LETTER TO COMMISSION

SUBJECT: South Pointe Park Dog Off-Leash Area Post Design Review Board Presentation Update

DESIGN REVIEW BOARD STAFF REPORT

RE: Design Review File No. 22894
1 Washington Avenue - South Pointe Park

**SOUTH POINTE PARK
PROPOSED CONCEPTUAL OFF-LEASH SITE PLAN
CITY OF MIAMI BEACH, FLORIDA**

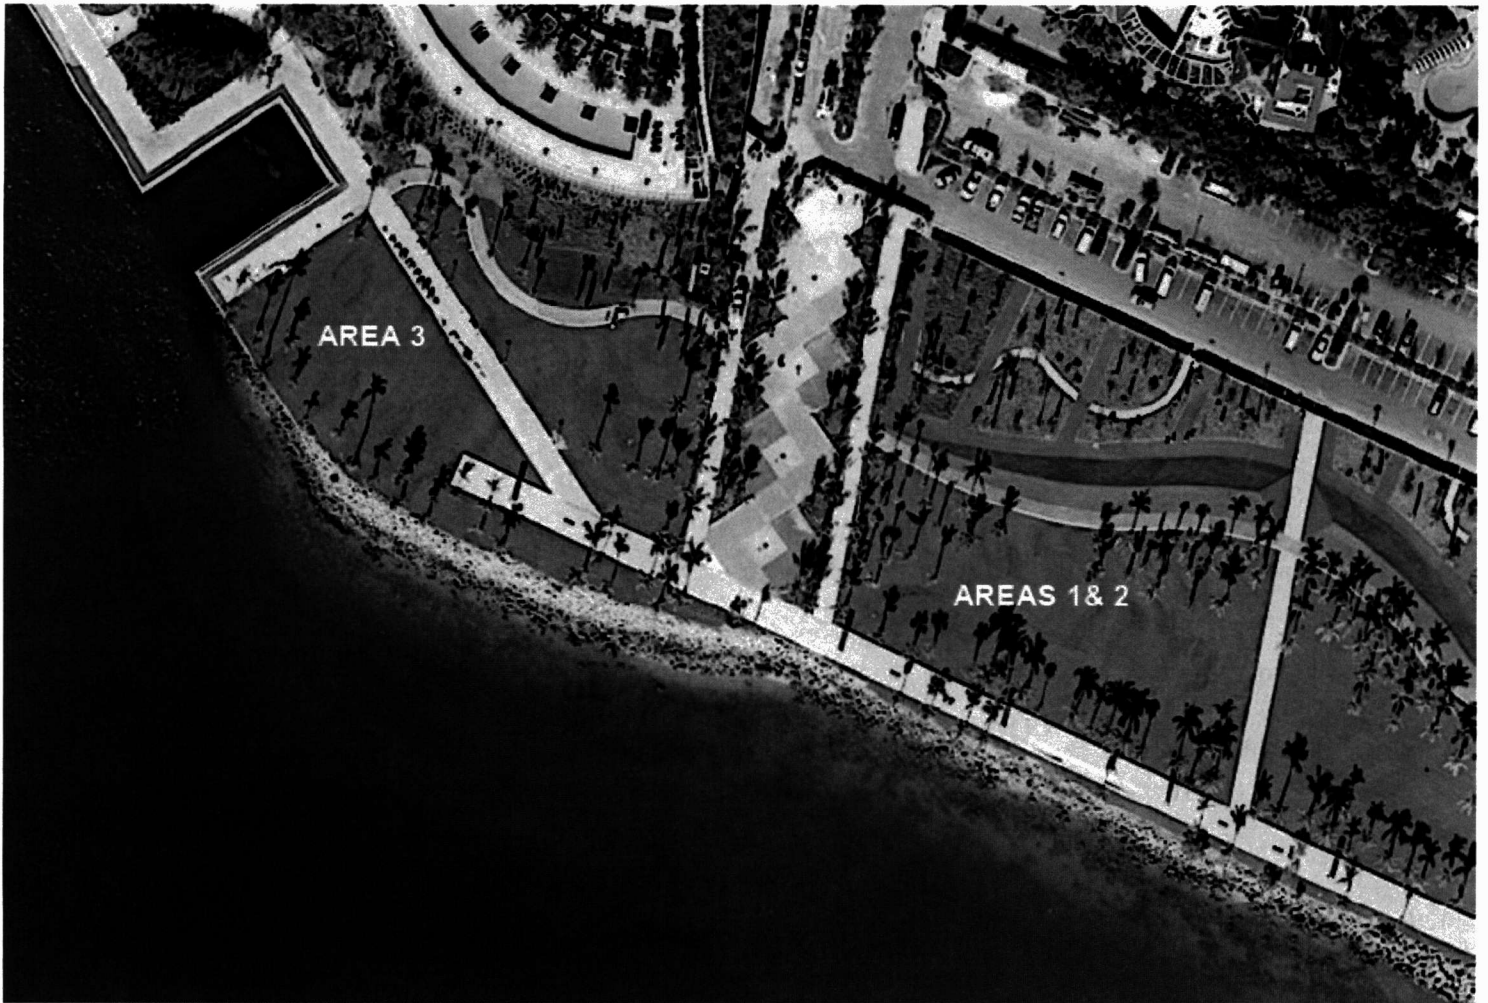
Continuous low shrubs are proposed around the general perimeter of the dog area, with breaks in the landscape material for access. This hedge material naturally would not exceed three (3') feet in height at maturity, but should be maintained at a maximum height of twenty-four (24") inches to minimize any adverse aesthetic impact. Although the City is requesting that the Board review and approve the hedge material in order to more clearly delineate the off-leash dog area for dog owners and park users, such hedge may not ultimately be required, particularly if Area #2 is selected, as this area would be defined by the existing "Cut-Walk" to the south and existing walkways around the remaining perimeter.

While staff believes that it is essential to maintain the design integrity of this nationally acclaimed public park, staff does not object to the proposal to delineate an appropriately selected location for an off-leash dog area with low perimeter landscaping material not to exceed eighteen inches (18") in height, if required, in addition to discreet park signage, as this should not have a significant adverse aesthetic impact upon the overall park design. Staff does, however, strongly recommend against Area #3 surrounding the Art in Public Places (AIPP) sculpture known as the "Obstinate Lighthouse" for the proposed off-leash dog area, for the following reasons: 1) it would be inconsistent with the South Pointe Park master planned location for the AIPP sculpture previously approved by the Design Review Board; 2) any form of perimeter landscaping material or additional park signage in this location would distract from and have a significant adverse impact upon the design integrity of the lighthouse sculpture as well as its open lawn setting, and; 3) this location could limit the close enjoyment of the AIPP lighthouse sculpture to only people, including young children, who are comfortable being around dogs that are off-leash. Consequently, staff recommends that Area #2, which includes Area #1, as the most suitable location for an easily accessible off-leash dog area in South Pointe Park.

- a. Area #3, the area surrounding the Art in Public Places sculpture, shall not be permitted.
 - b. Area #2, the area located immediately to the east of the Washington Ave plaza and which includes Area #1, shall be permitted as an off-leash dog area, or alternatively, Area #1 alone may be permitted as an off-leash dog area.

- c. If a hedge is required to delineate the off-leash dog area, it shall be installed in substantial accordance to the plans submitted, and should be maintained at a maximum height of twenty-four (24") inches, subject to the review and approval of staff.

- 1. There shall be no hedge to define the area.
 - 2. It shall not be located in area #3, surrounding the art in public places "lighthouse" project.
- C. The Final Order is not severable, and if any provision or condition hereof is held void or unconstitutional in a final decision by a court of competent jurisdiction, the order shall be returned to the Board for reconsideration as to whether the order meets the criteria for approval absent the stricken provision or condition, and/or it is appropriate to modify the remaining conditions or impose new conditions.

SOUTH POINTE PARK
2009 AERIAL VIEW - OF PROPOSED OFF-LEASH AREAS

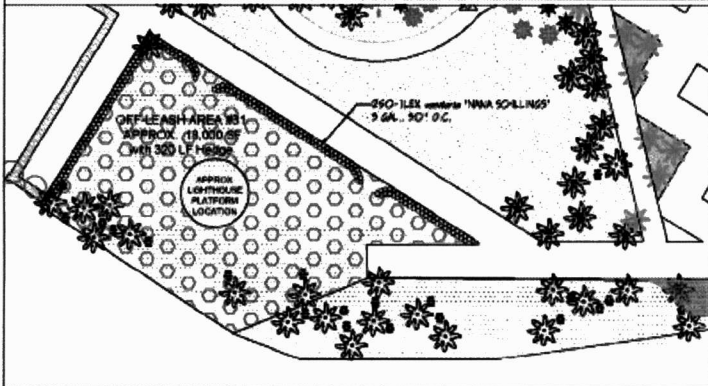
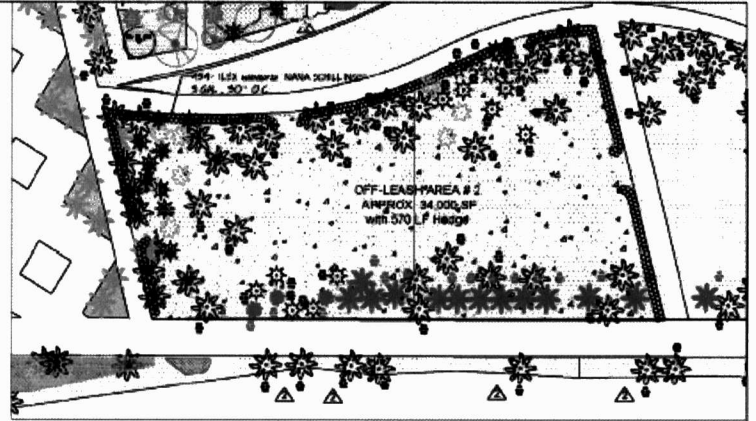
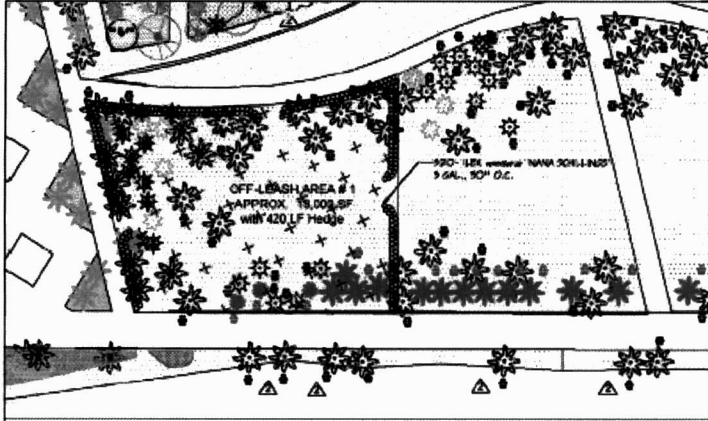
The City is proposing three alternate plans for an off-leash dog area within South Pointe Park. Areas #1 and #2 are generally located to the east of the Washington Avenue plaza extension and south of the walkway that follows the berm. Area #1 is approximately 18,000 S.F. (0.41 acres), and Area #2, which includes area #1 is approximately 34,000 S.F. (0.78 acres). Area #3 is located surrounding the recently completed light house sculpture at the west end of the park, and is approximately 18,000 S.F. (0.41 acres).
